SUBCOMMITTEE ON MATERIALS

2017 Mid-Year Meeting
Wednesday January 18, 2017
2:00 – 4:00 PM EST

TECHNICAL SECTION 4b
Flexible and Metallic Pipe

Figure 1 of PP 63 was show on screen page 4 of these meeting minutes.

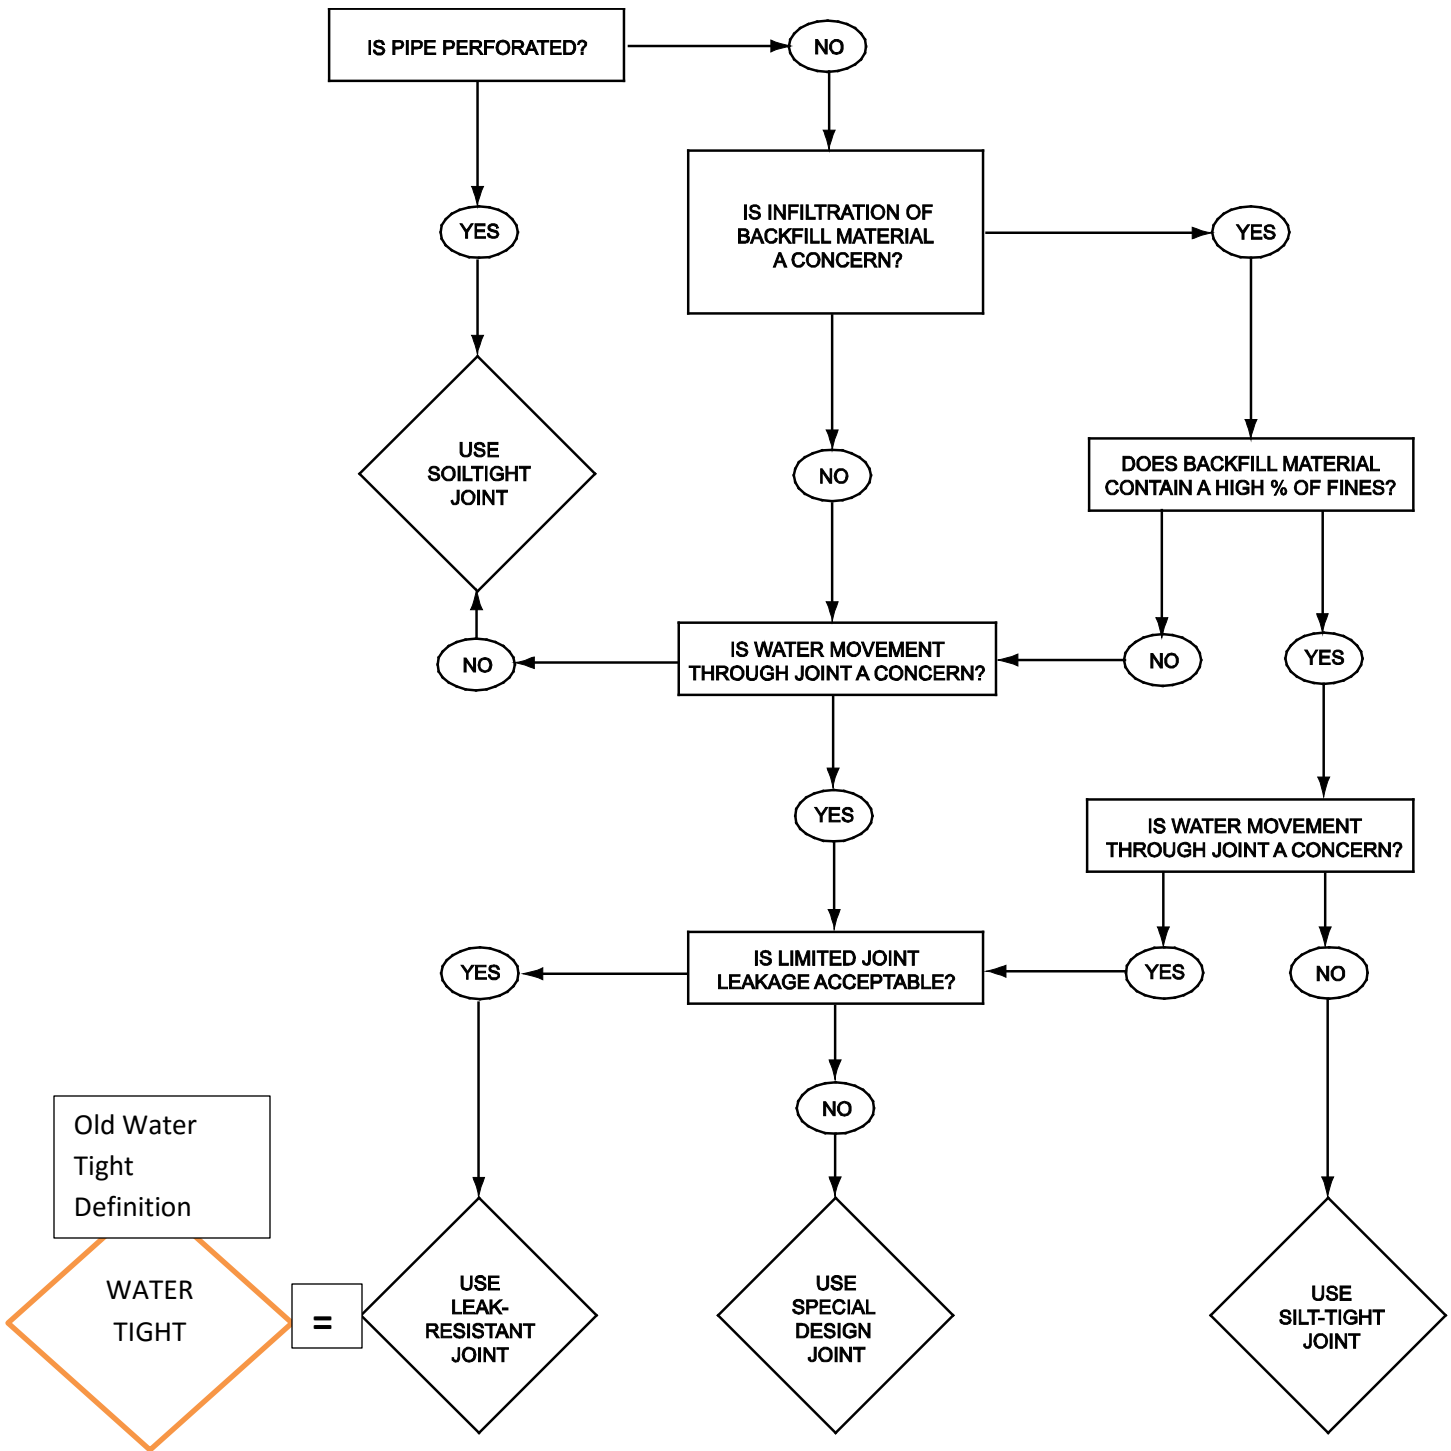
Would still prefer to see Figure 1 page 70 of 84 read "IS LIMITED JOINT LEAKAGE ACCEPTABLE?"

--> NO

--> USE WATERTIGHT JOINT

AND perhaps another layer that asks if pull apart, shear, or bending strength is needed then to select a SPECIAL DESIGN JOINT

Discussion: Bill explained the old definition of water tight used in sanitary sewer specifications and in some older AASHTO construction specification has been zero (0) leakage in a plant test with an allowance for some leakage after construction in a field test. This allowance is 200 gallons/in-diameter/mile/day. This is the same definition PP 63 is using but calling the joint leak resistant because there is a leakage rate allowed in the constructed joint. Bill used the diagram on page 4 to demonstrate and describe this to the technical section. Leak Resistant = Old Water tight definition.

Resolution: Bill had called Michigan and discussed with them the definition of water tight and leak resistant in PP 63. PP 63 will be moved forward and published as a full standard.
